## 1 ADDENDUM #1

- .4 Reference Section 01 10 00 - Summary:
  - .1 Reference Paragraph 1.16.1:
    - .1 Delete as written and replace with the following:  
"Regular bi-weekly project meetings at the site are NOT required for Contract #1 - Roof Replacement, however, the Client has the right to request progress meetings as needed."

**1** NEW ROOF PLAN - PARTIAL  
ASK-101 1 : 100

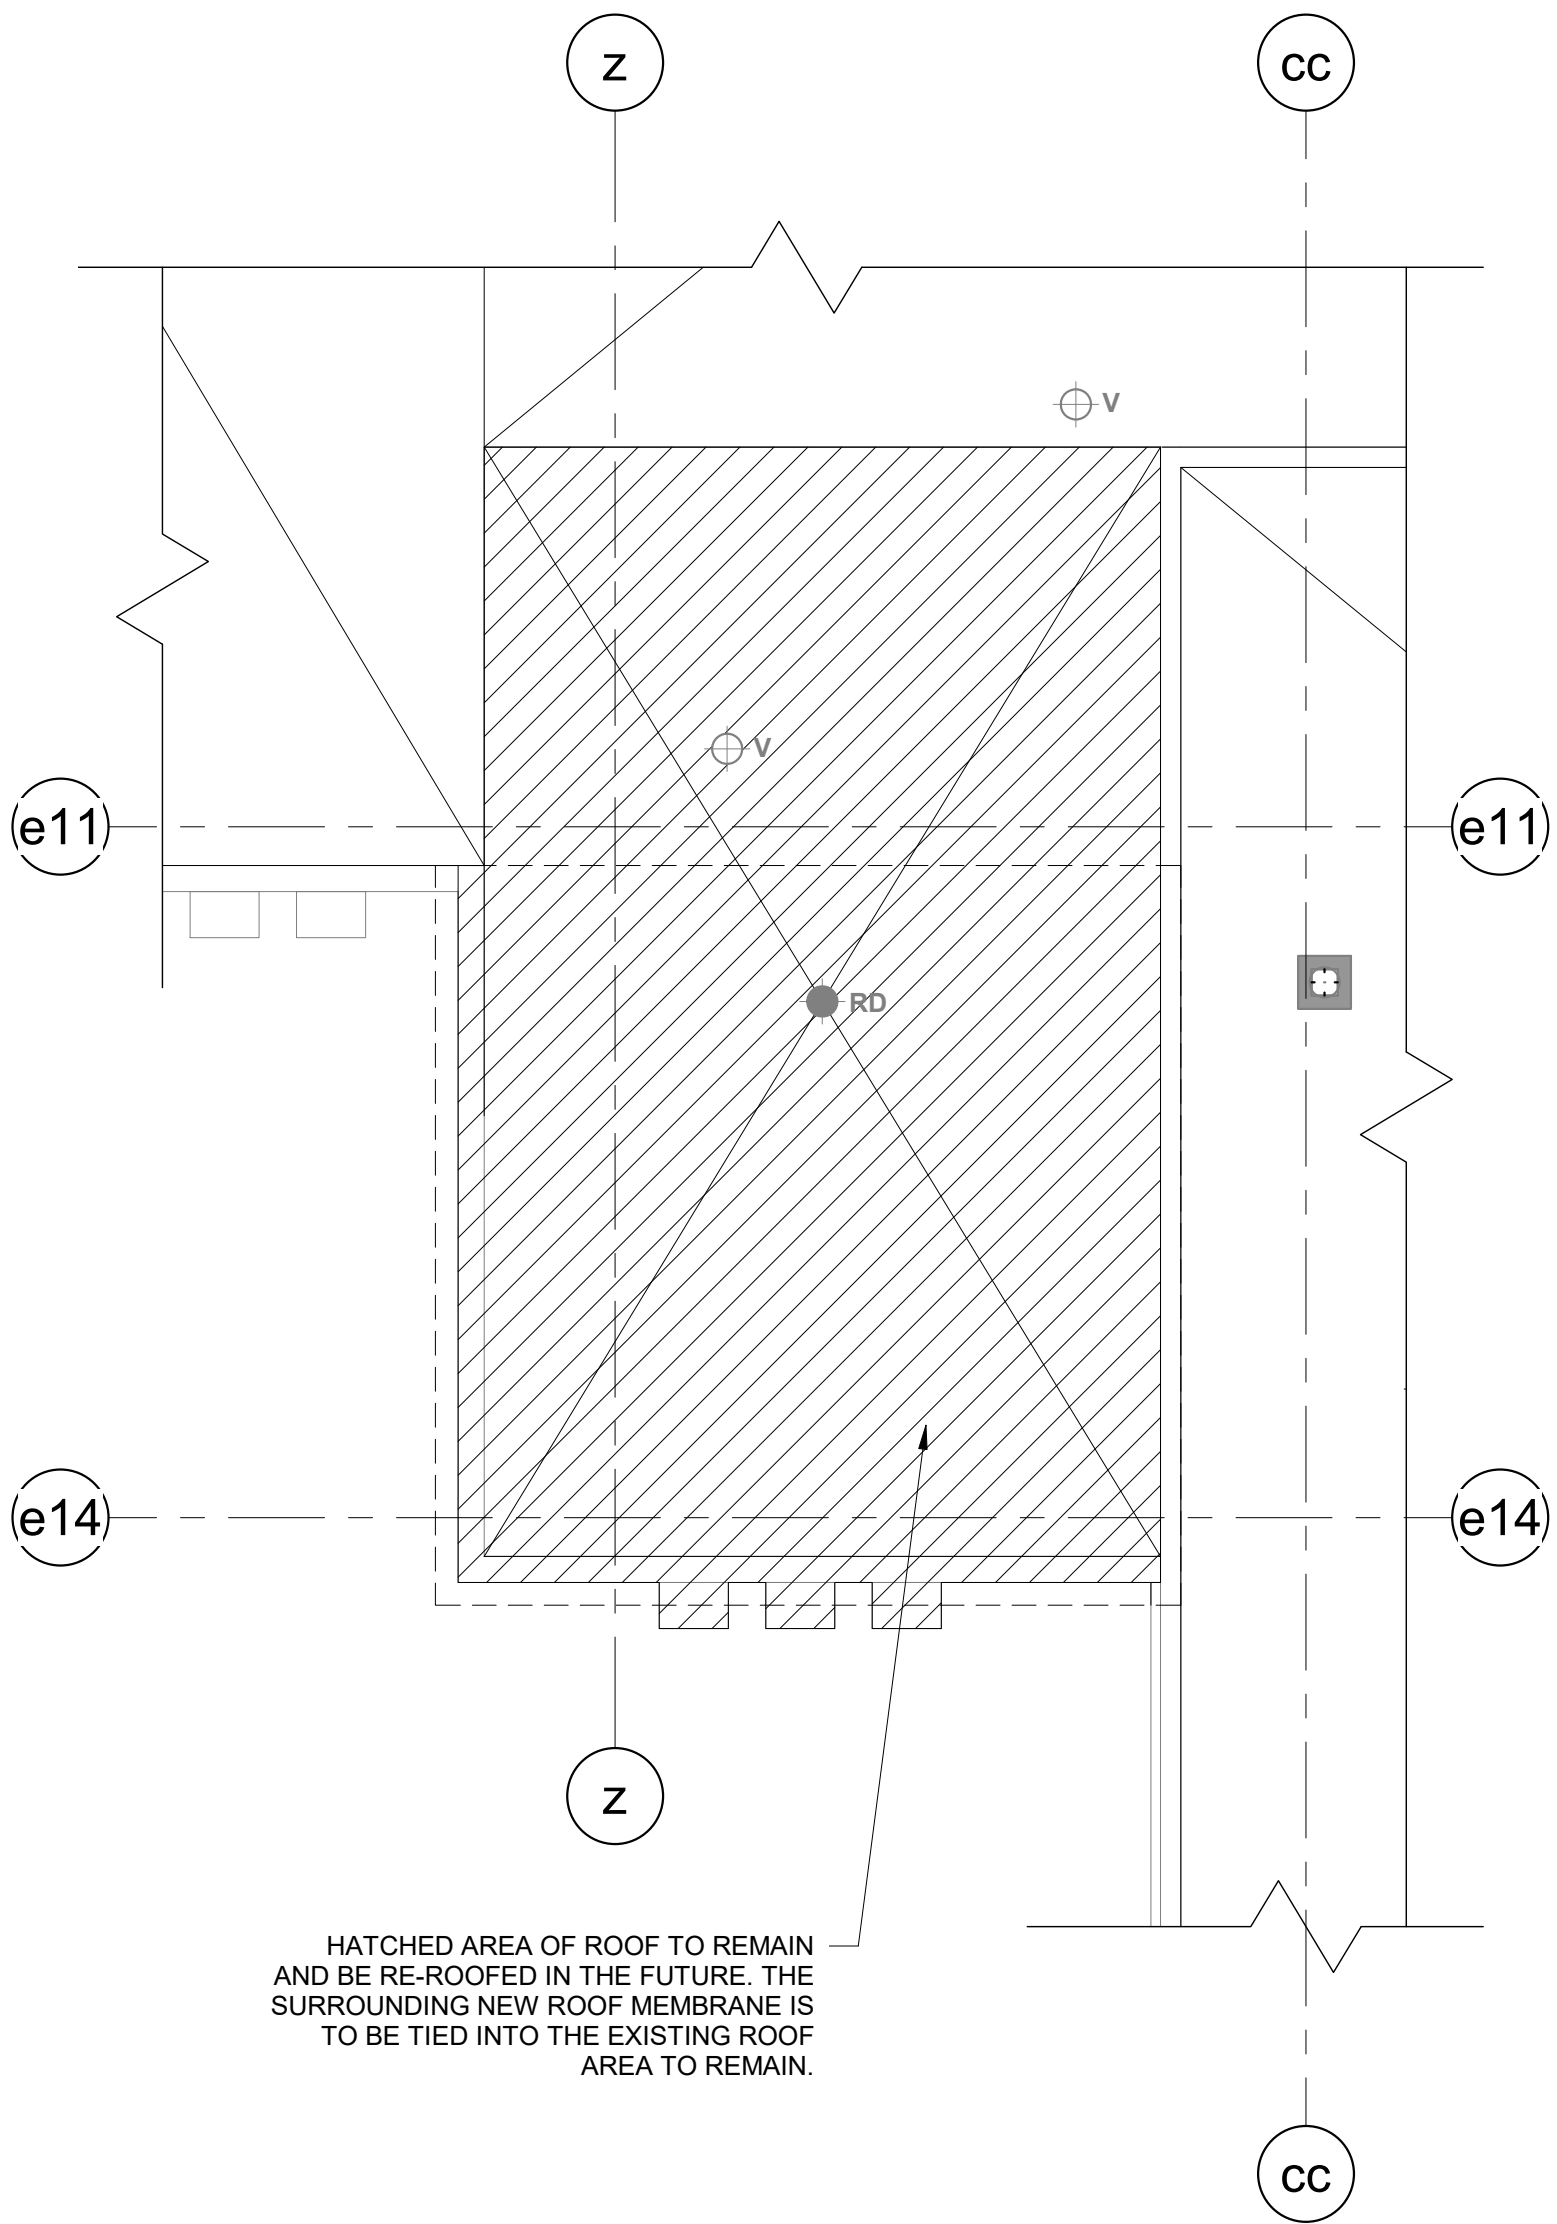
- .2     Reference Drawing A1-101 New Roof Plan:
  - .1     Do not re-roof the area noted in attached sketch ASK-101. This area will be re-roofed in the future. The new roof membrane is to be tied into the existing roof area that is to remain.

HATCHED AREA OF ROOF TO REMAIN AND BE RE-ROOFED IN THE FUTURE. THE SURROUNDING NEW ROOF MEMBRANE IS TO BE TIED INTO THE EXISTING ROOF AREA TO REMAIN.
